Amendment 0001 is hereby incorporated into solicitation SP3100-08-B-5011 and shall become part of any contract.

Amendment 0001 is being issued to add additional work to the requirements of solicitation SP3100-08-B-5011 and to correct a typographical error in the specifications.

1. Reference Building 69-Project No. 3629 HVAC System Improvements Building 69

2. Reference Building 286-Project No. 3628 HVAC System Improvements Building 286

Building 286:

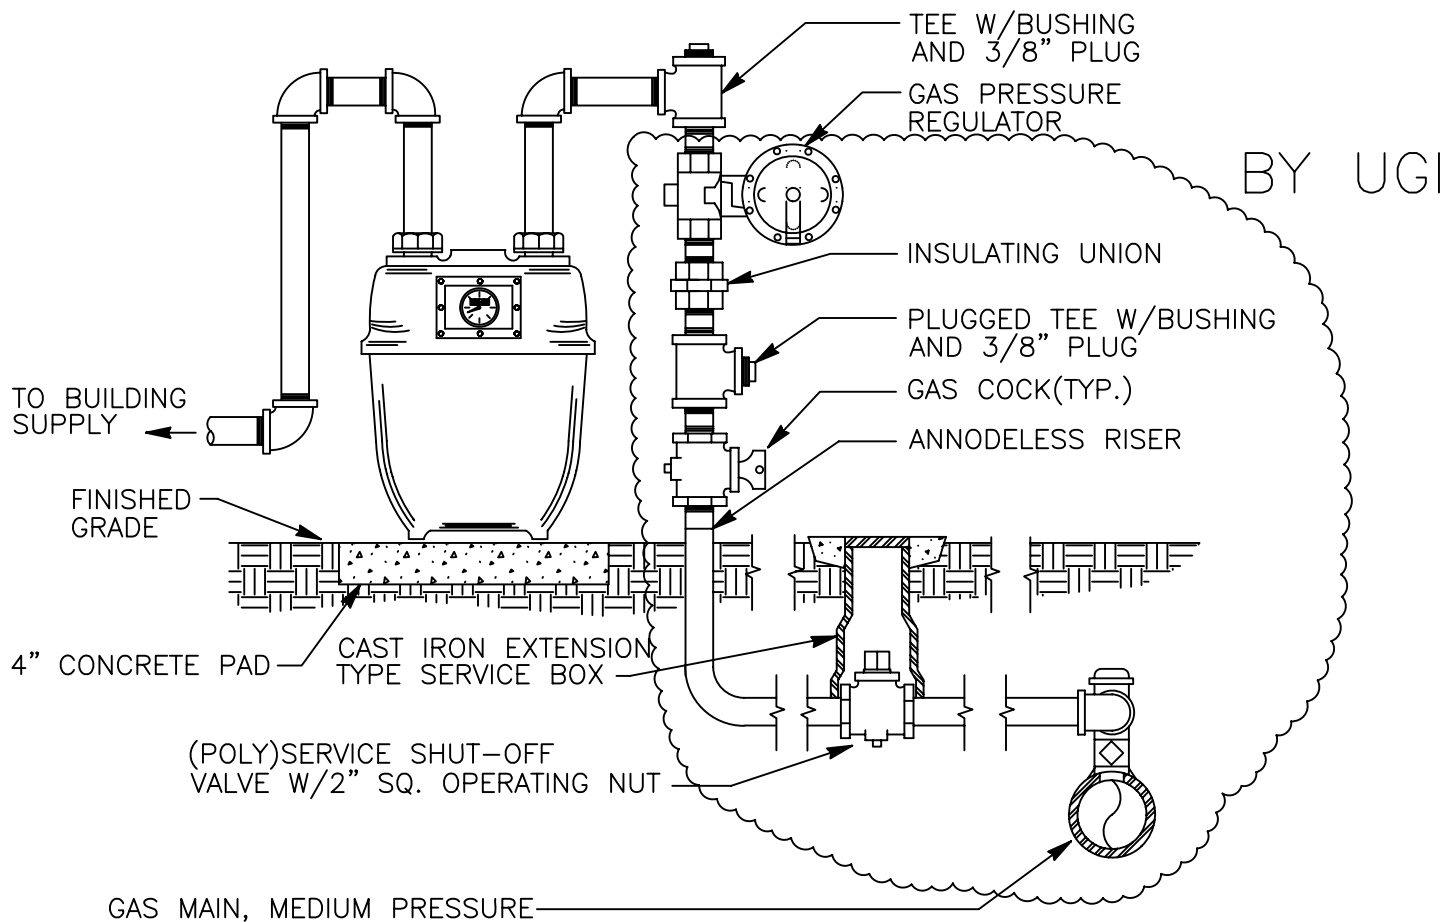
Building 287: Install new gas meter in existing gas service. UGI line is a 1-1/4" sch 40 line. Use 1-1/4" line into and out of meter installation and then install a 1-1/4" x 1" reducer onto existing gas line. Install pipe unions as needed. See attached typical detail and photos.

Install new gas meter into new gas service piping for building 286. See attached typical detail and photos.
